Service Bulletin

Subject: RUST ON LIFTGATE OPENING	Bulletin No:	09-039/15
	Last Issued:	10/07/2015

2013-2016 CX-5 vehicles with VINs lower than JM3KE*****688079 (produced before June 7, 2015)

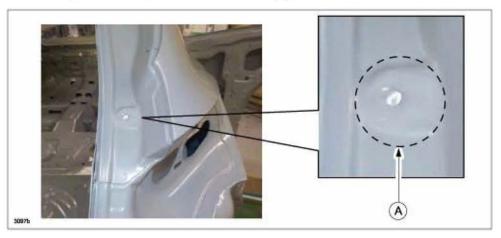
Some vehicles may exhibit rust (A) on the liftgate opening around the left and/or right side stopper (B). The paint in this area may be thinner than normal due to production variances.

- 1. Verify the customer concern.
- 2. Repair the rust/blister damage using normal body shop repainting procedures.
 - **NOTE:** The area of possible thin paint is shown below (A).

- 3. Install a new protective film over the stopper area after the paint has fully dried.
- 4. Verify the repair.
